URGENT Field Safety Notice

MR System Patient Support may experience restricted horizontal tabletop movement

Reference: MR Systems Integrated Radio Frequency (IRF) Carrier Assembly screws (reference FCO78100588)

Figure 1. IRF Carrier protruding screws

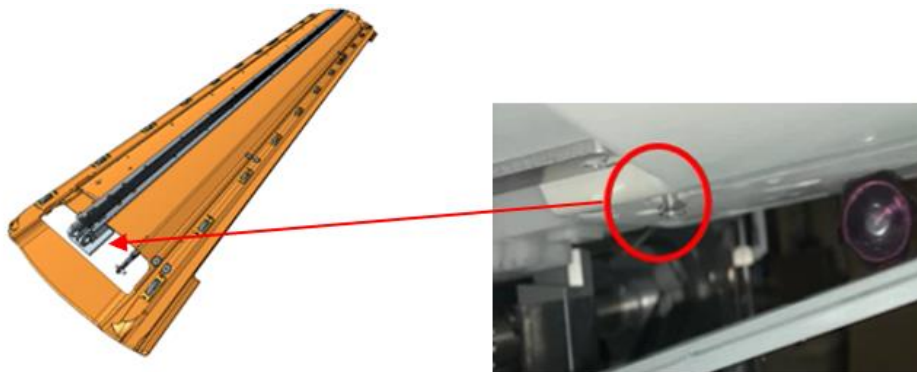
Philips has identified an issue in the MR System Patient Support where the Integrated Radio Frequency (IRF) Carrier assembly screws may come loose and protrude beyond the surface (Figure 1). This could cause the screws to interfere with other moving parts, potentially blocking the horizontal tabletop movement.

Philips will contact you to schedule time for a Field Service Engineer (FSE) to visit your site to inspect the IRF carrier assembly and provide a correction if necessary (reference FCO78100588). Philips plans to start implementing corrections in Q4 2024.

Figure 2. MR System (left image: 1) MR Magnet; 2) Patient Support; 3) IRF Carrier) and IRF carrier (middle and right image).

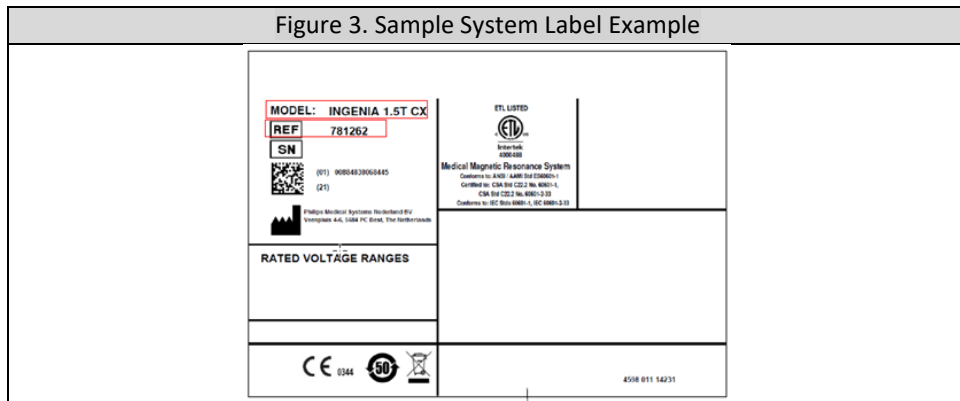
The IRF Carrier (Figure 2, Item 2 and 3), a component of the Patient Support within the MR system, supports the tabletop where the patient lies. As the patient moves into the MRI tunnel, the tabletop, supported by the IRF Carrier, forms a container for positioning the posterior coil.
